Addendum No.: 2

York Correctional Institution Central Plant and Piping Distribution

BI – JA – 465

The following clarifications are applicable to drawings and specifications for the project referenced above.

6 HEAT TRACING DETAIL AT ENCLOSURES

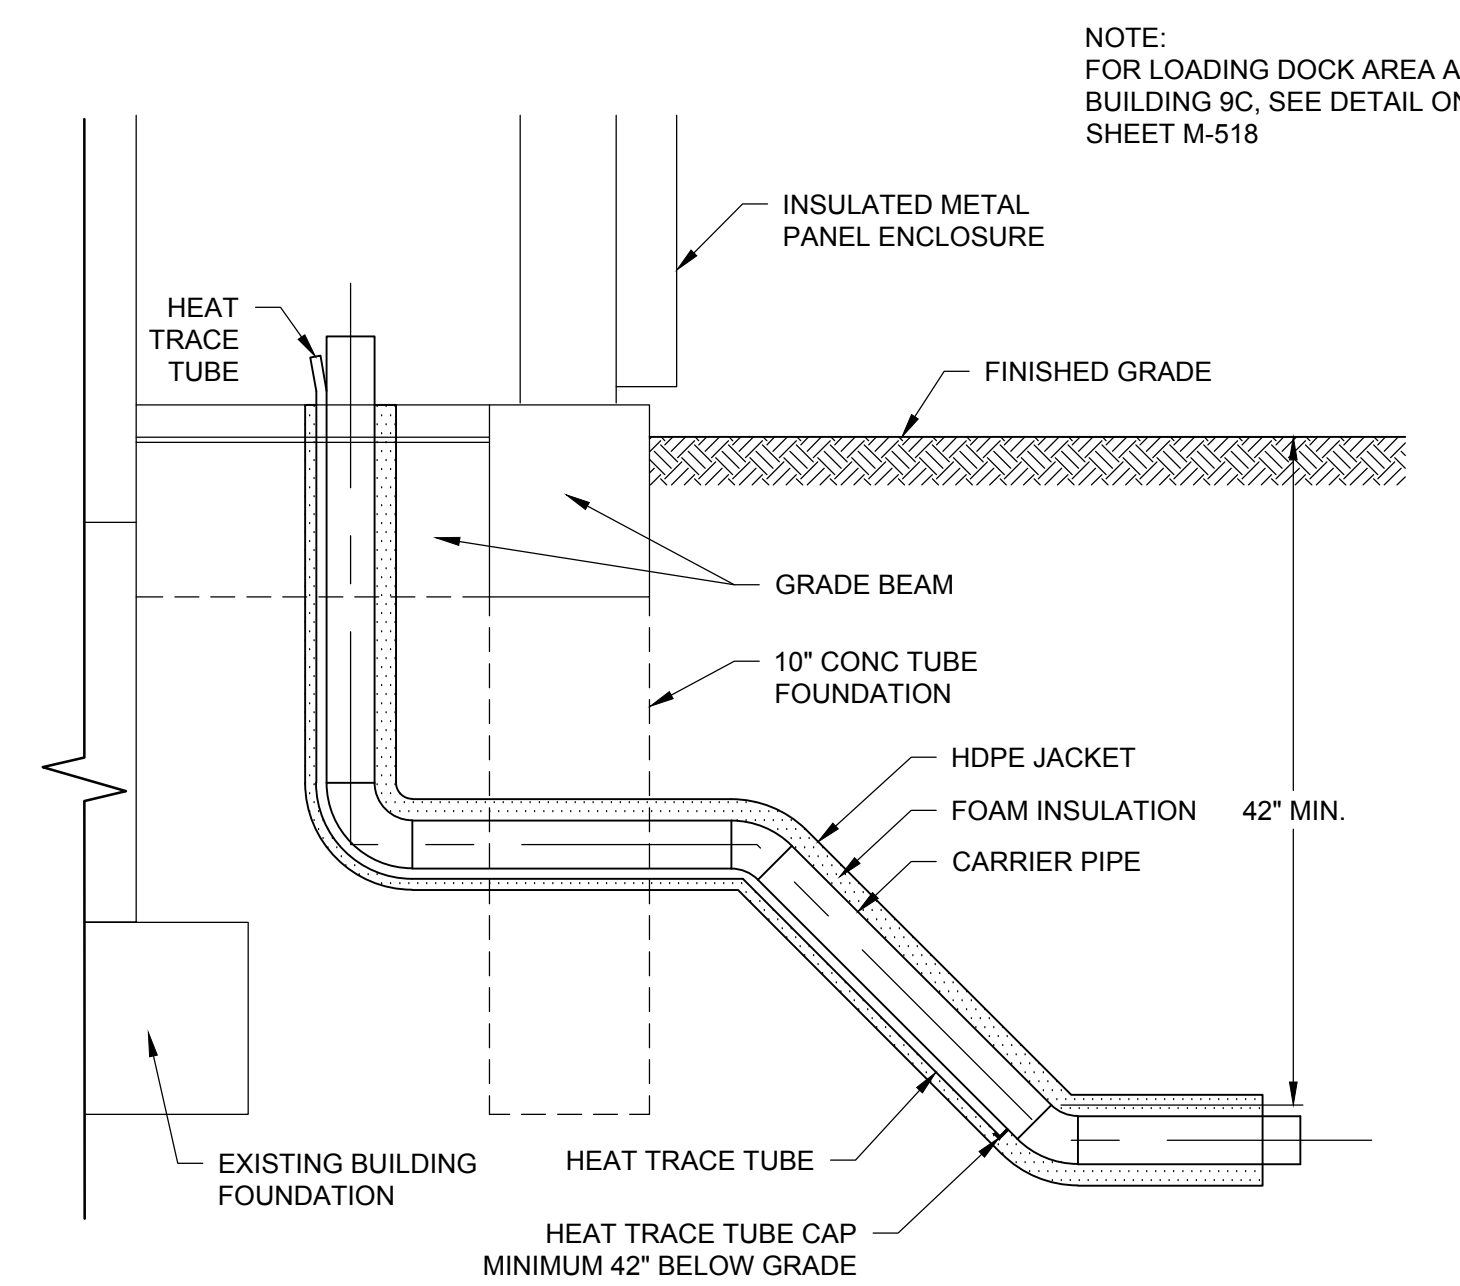
Drawing C502 Site Details

REPLACE the entire drawing with the attached.

UPDATED detail 6 title for clarity.

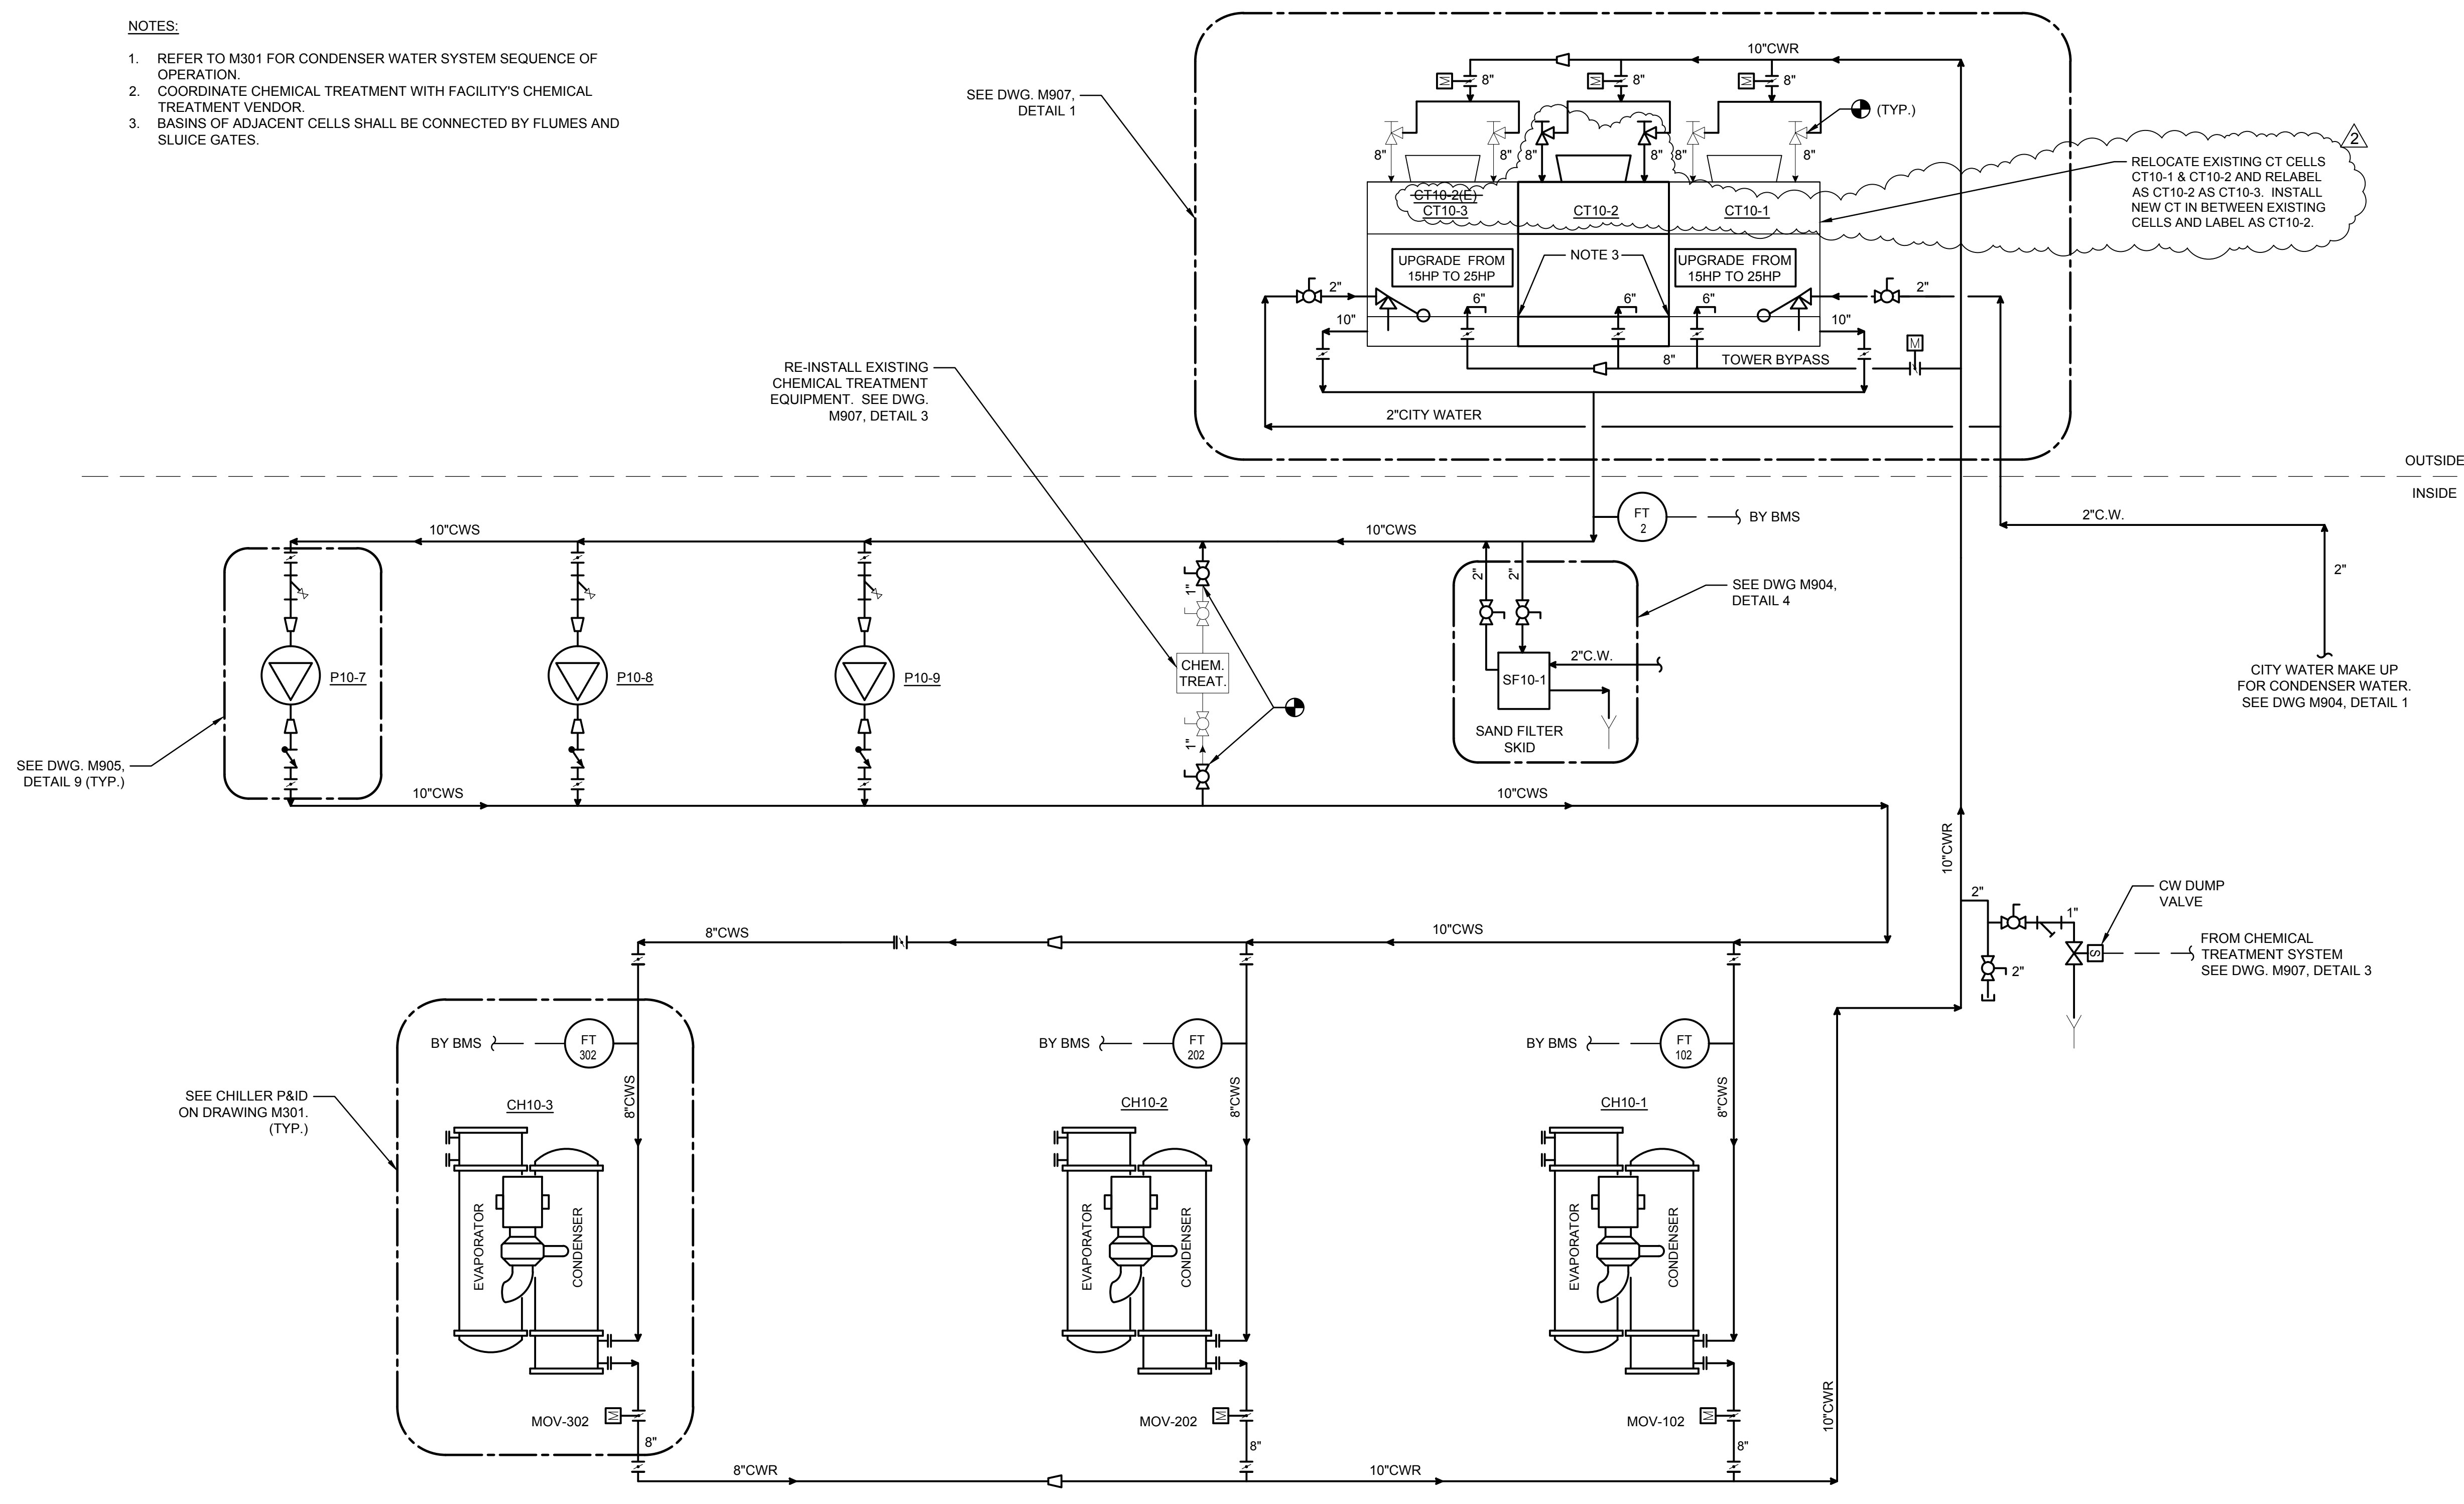
Drawing M204 Plant Condenser Water Flow Diagram Installation

REPLACE the entire drawing with the attached.

BUILDING 10 CONDENSER WATER FLOW DIAGRAM INSTALLATION PHASE 5

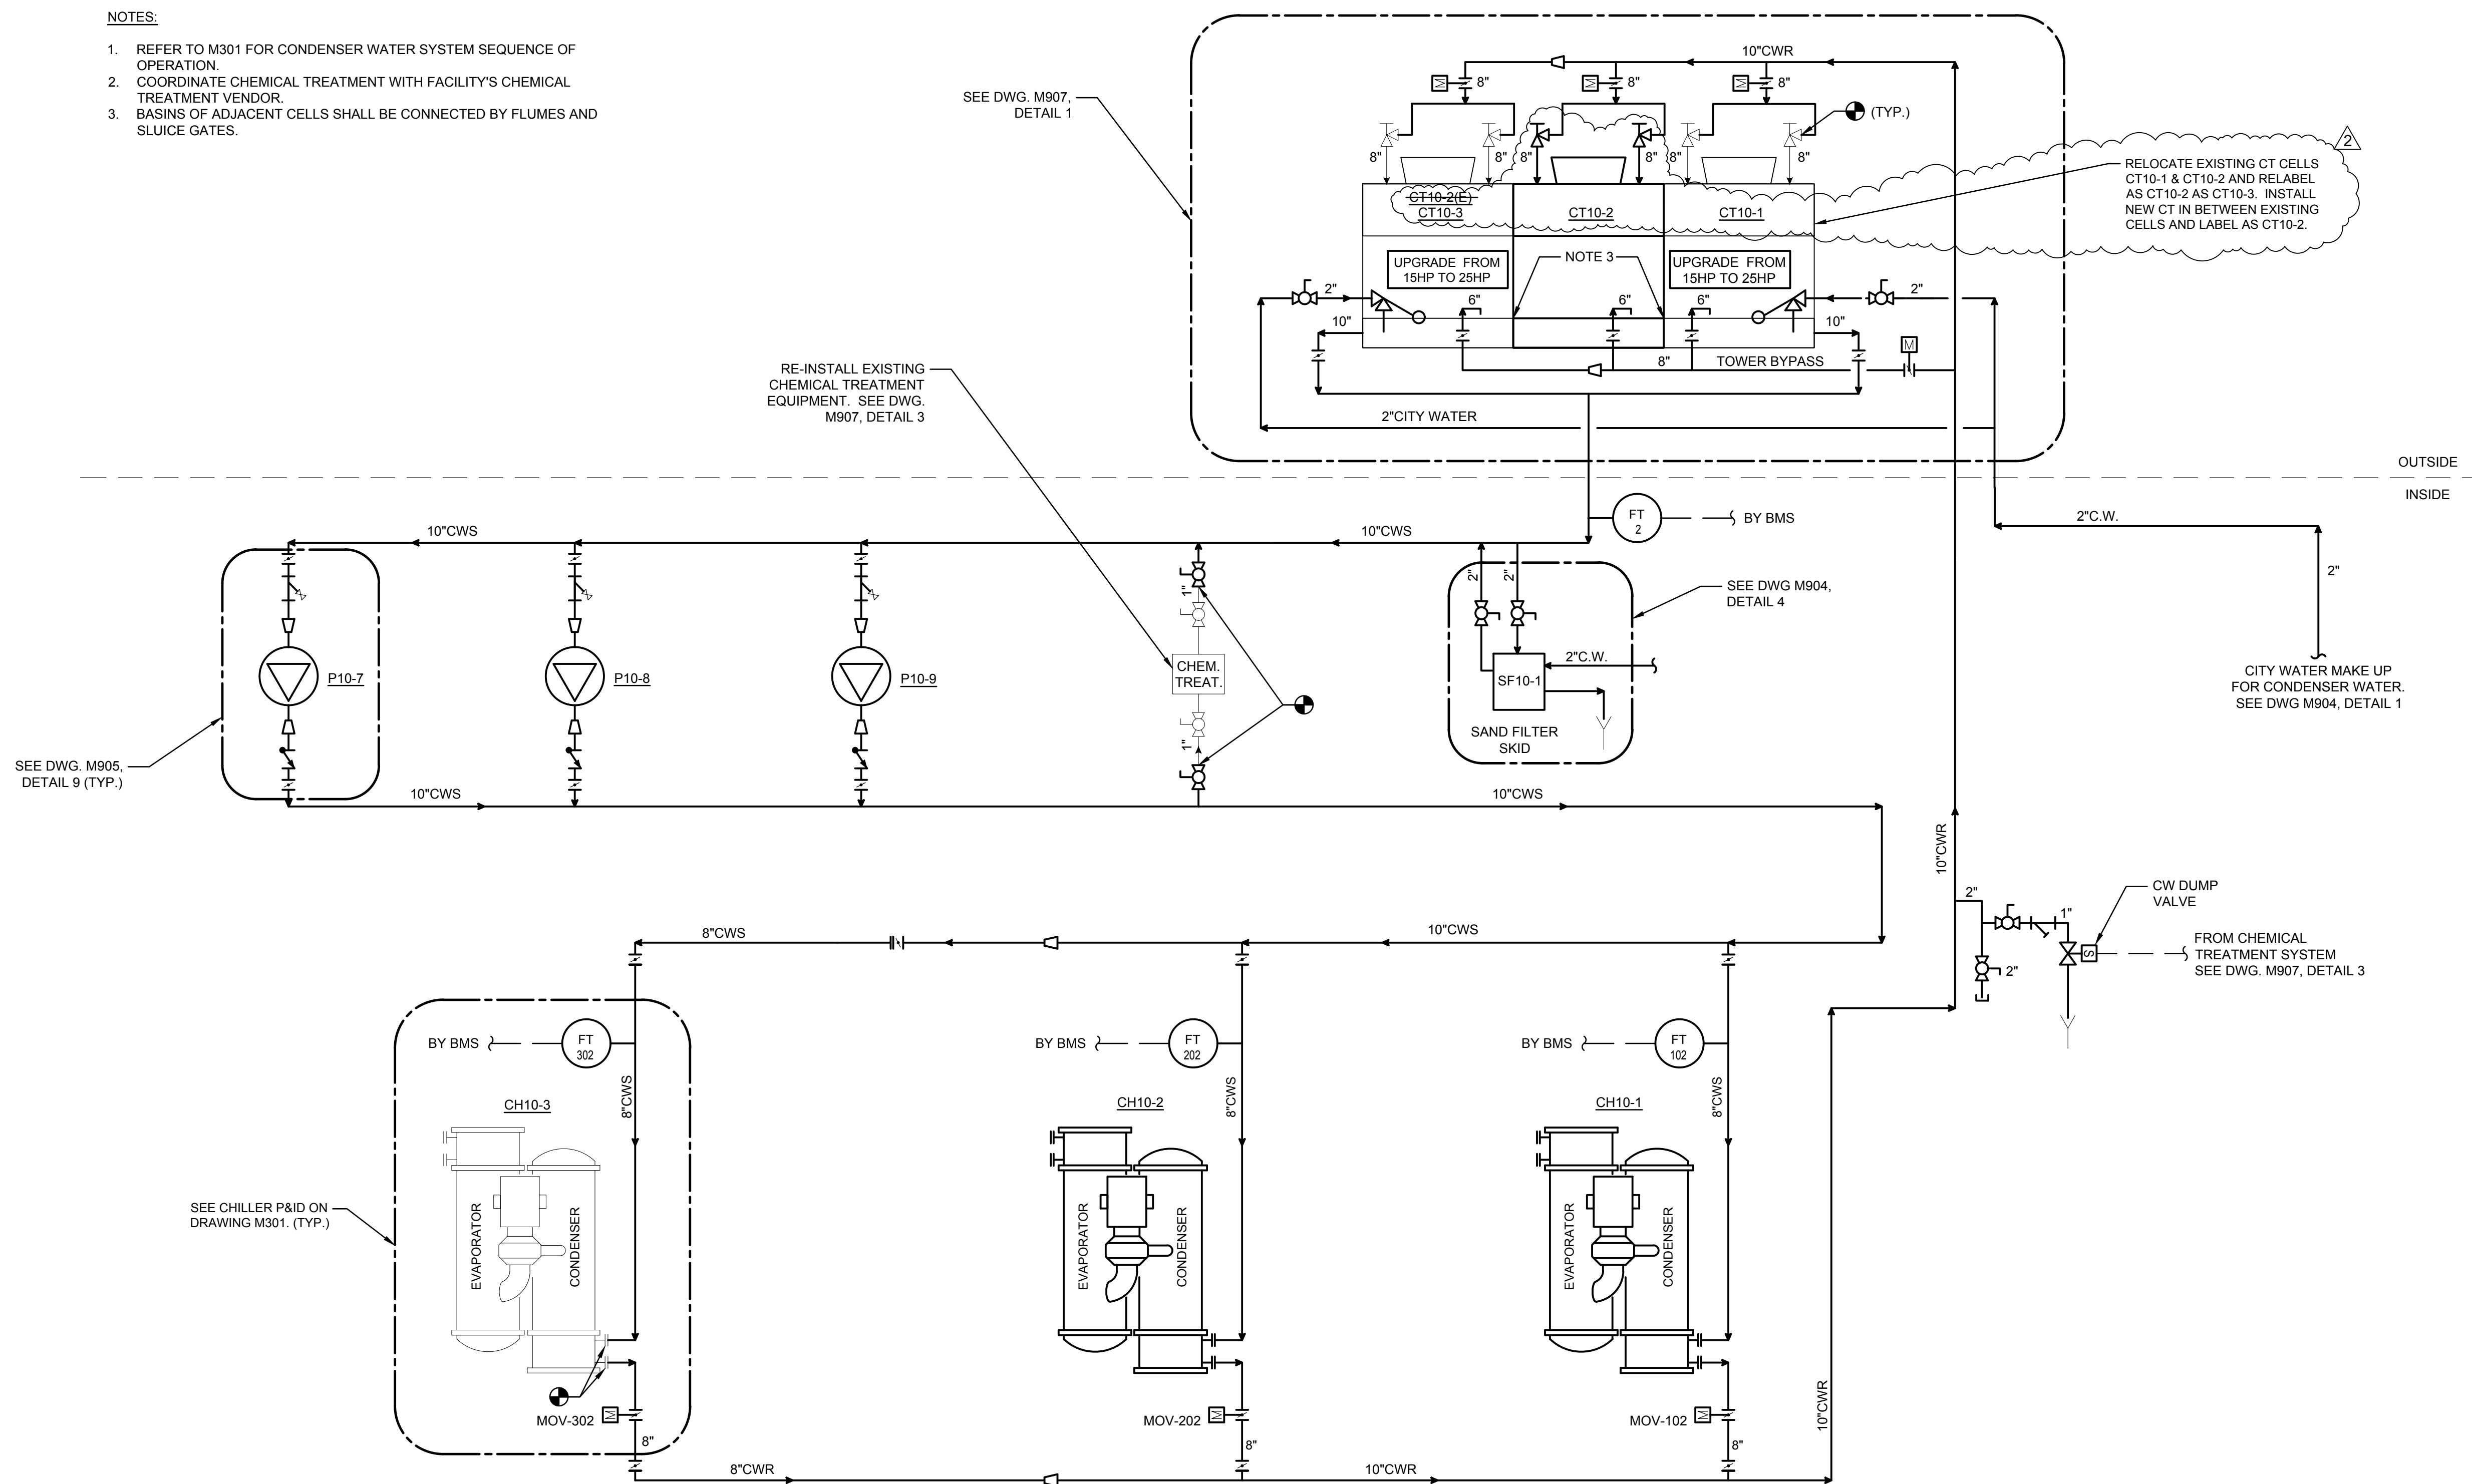
Drawing M406 Plant CW Flow Diagram Installation Phase 5

REPLACE the entire drawing with the attached.
